Ansty Garden Community: Flood Risk Assessment and Outline Drainage Strategy

P25035_R2_Rev2
September 2025

Document reference	Issue date	Comments	Written by	Approved by
P25035_R2	May 2025	Final	JEM	MJF
P25035_R2_Rev1	August 2025	Final (following LLFA feedback)	JEM	MJF
P25035_R2_Rev2	September 2025	Final (following further LLFA feedback)	JEM	MJF

This report has been revised/updated based upon feedback received from the Lead Local Flood Authority in August 2025. The following table itemises all comments raised and the revisions that have been made to address each point.

Appendix G Outline drainage strategy

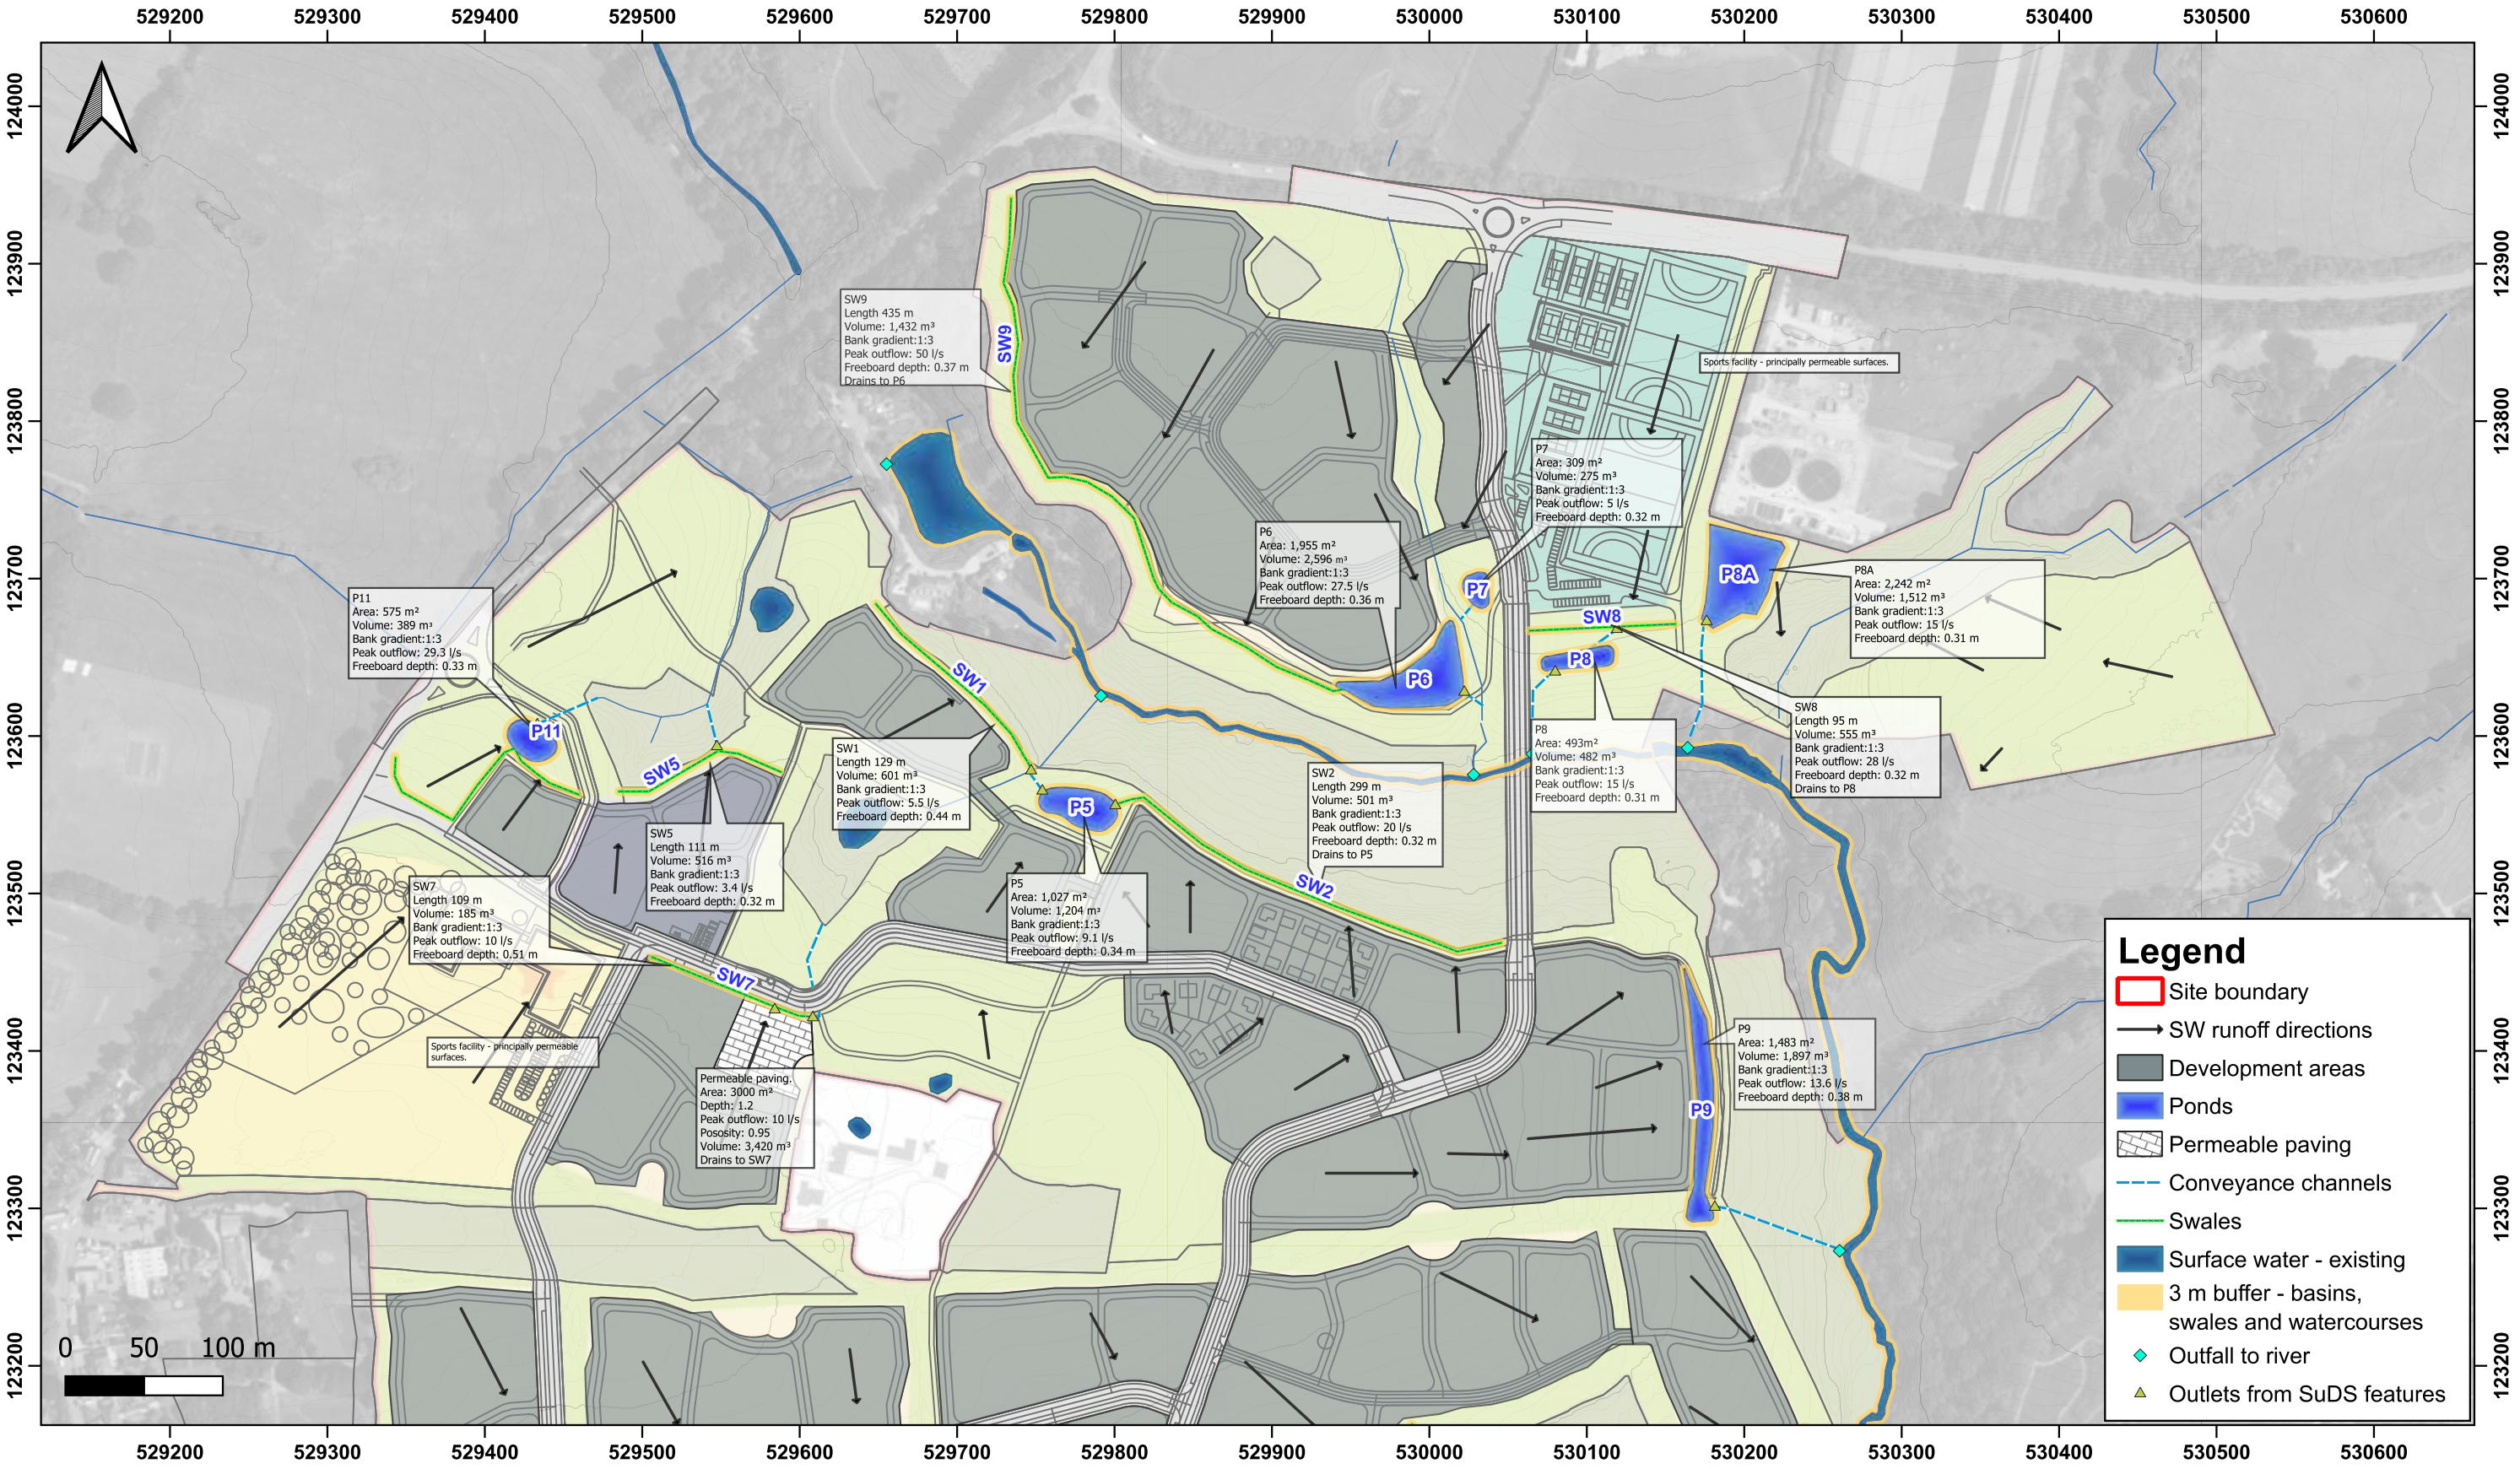
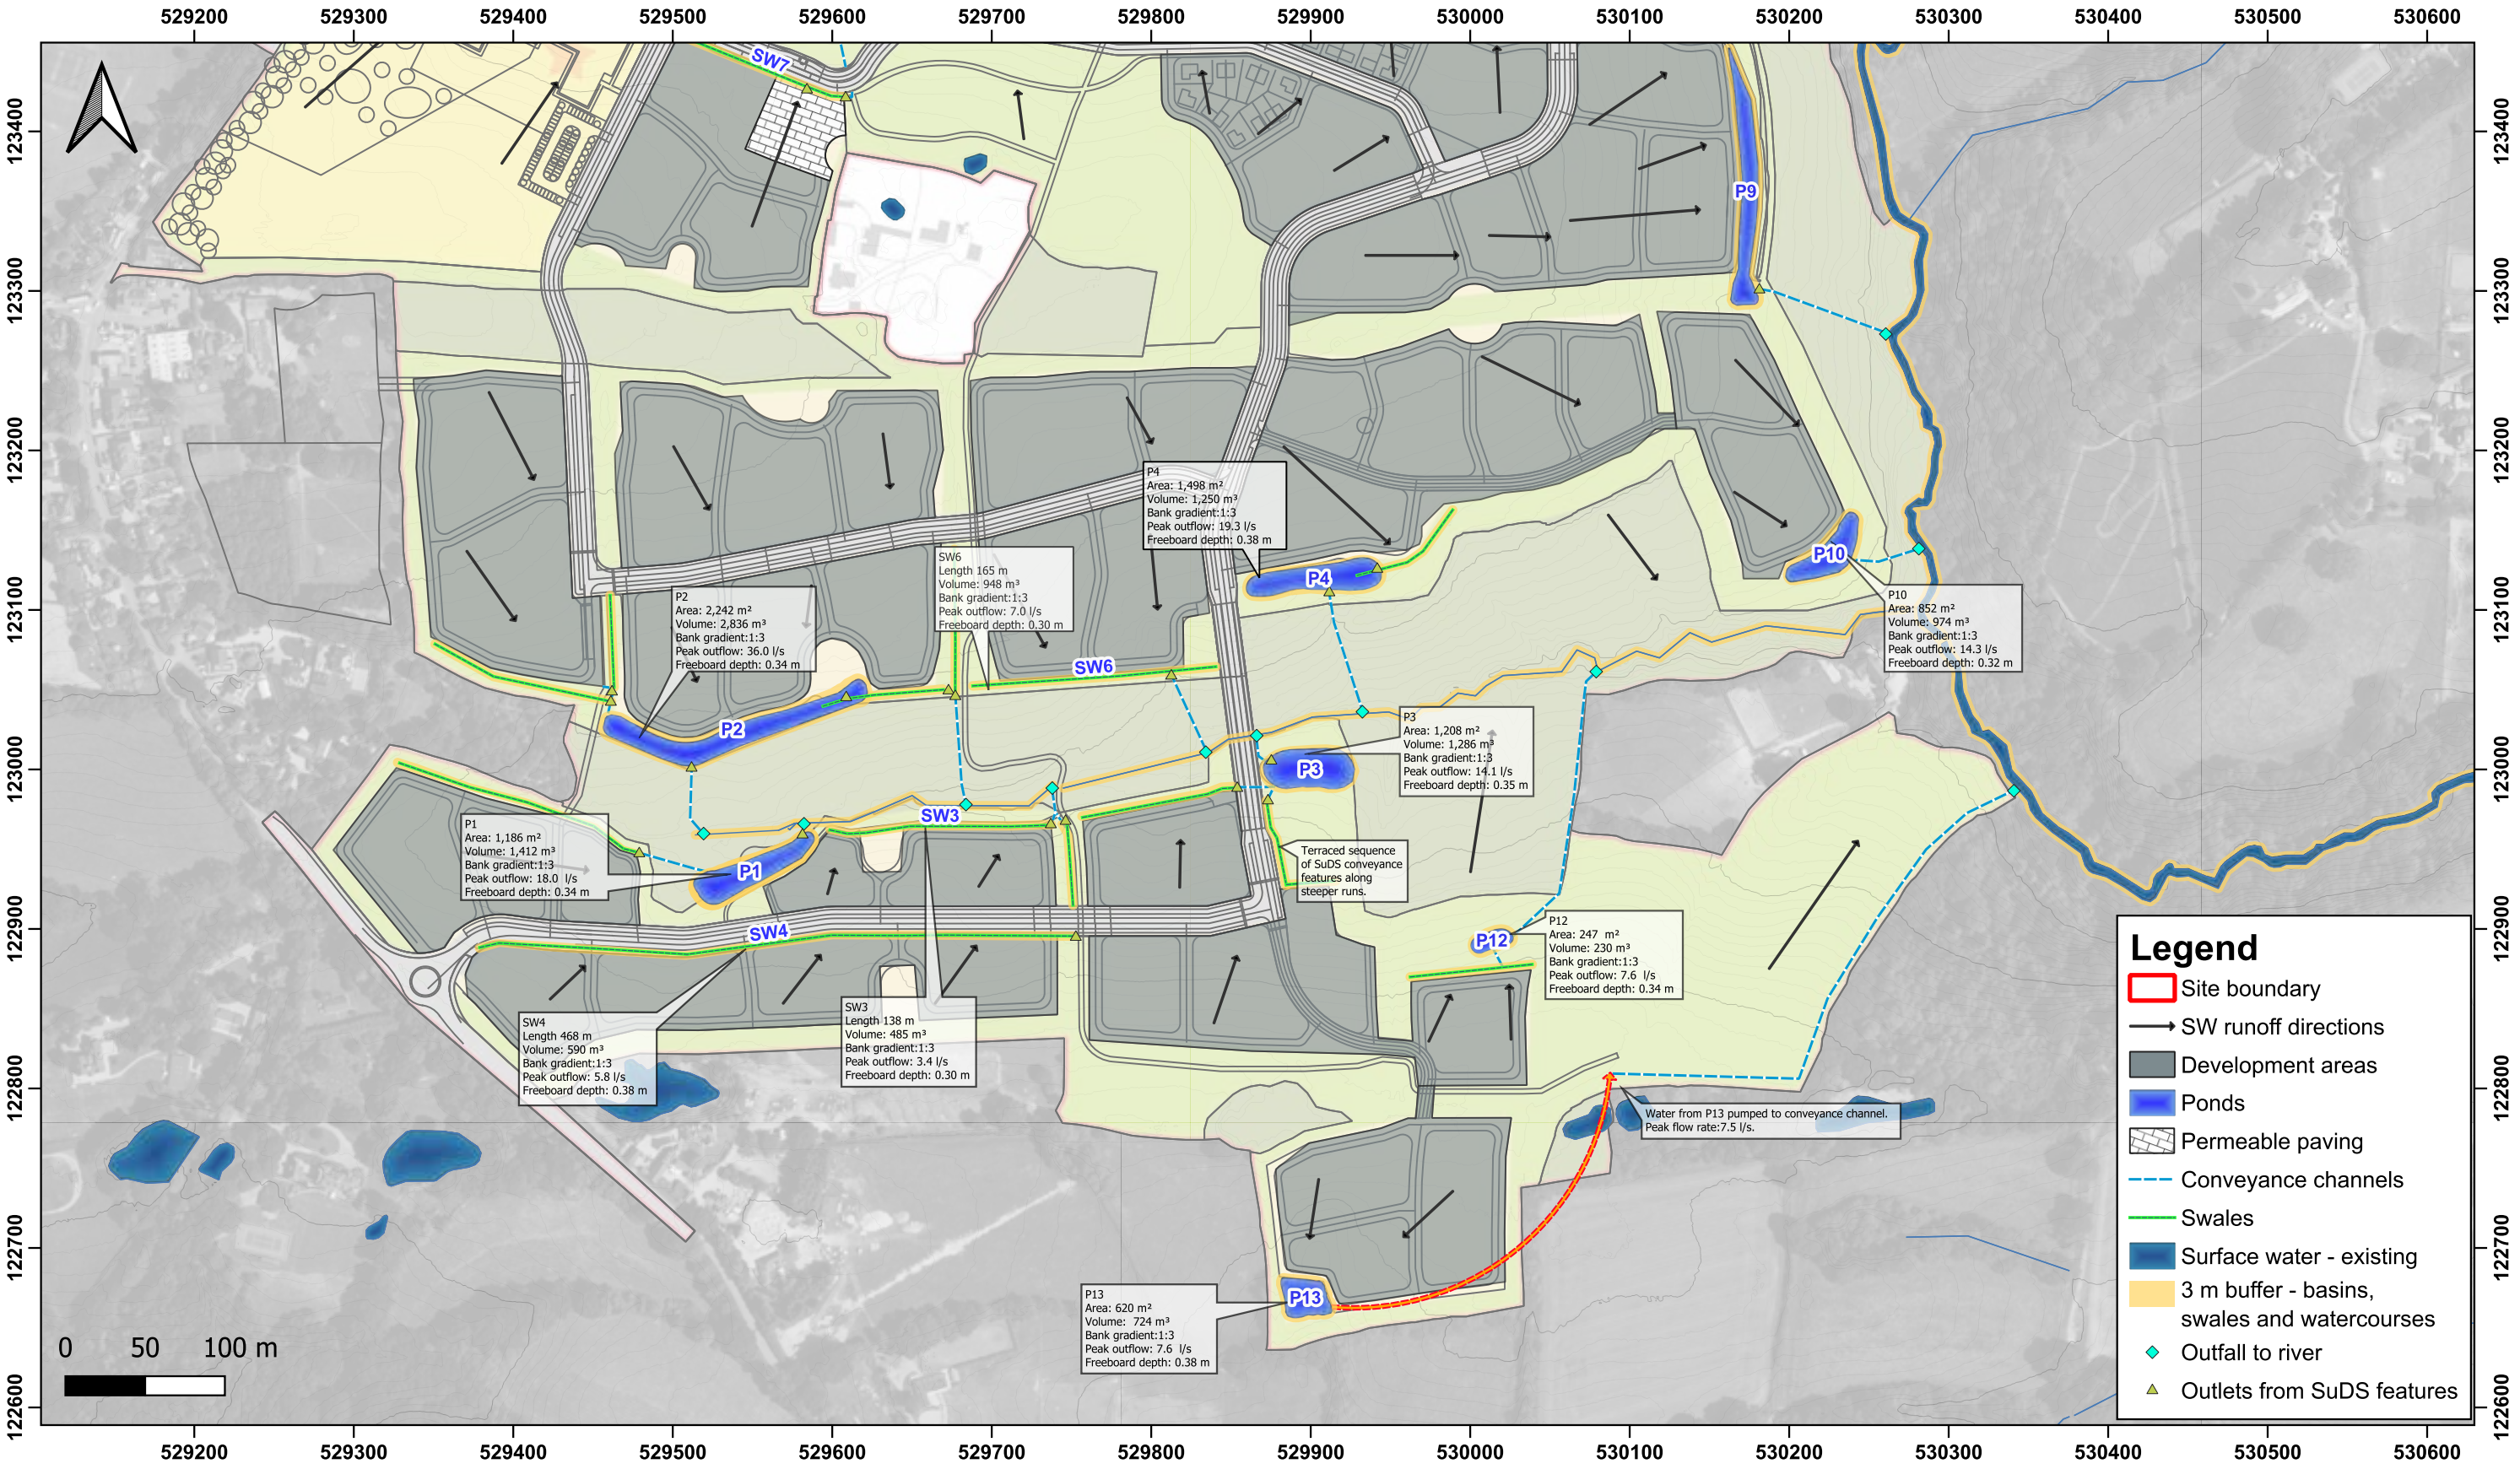
4. At outline planning stage, we require an outline drainage layout showing proposed location of drainage components, storage volumes, outfall locations and a rough idea of flow rates from each outfall. 3m easements will be required around basins and swales. All outfalls to watercourses must be within the red line boundary, or third party agreements will need to be provided at outline stage.	The drainage layout plans within Appendix G have been enhanced to make the requested information more clearly visible.

5. The watercourses must have a 3m easement to allow riparian maintenance to take place.	This information has been added to the drainage layout figures (Appendix G).

Comment	Response
1. Only the northern section of the outline drainage layout has been updated as requested.	Southern area now included.
2. A Cv value 0.75 is still being used in the Design Settings. A Time of Entry of 5 minutes should be used instead of 10 minutes (with some additional variation). The Additional Storage should be 0.	The Design Setting Cv has been revised (although this does not affect the simulation results, just the initial pipe sizing). The ToE and additional storage settings have also been amended as requested. The size and freeboard depths of all features have been adjusted to allow for these changes.

Outline drainage layout and relevant design information.
Freeboard depth = max water level under T30+CCA event minus bank level
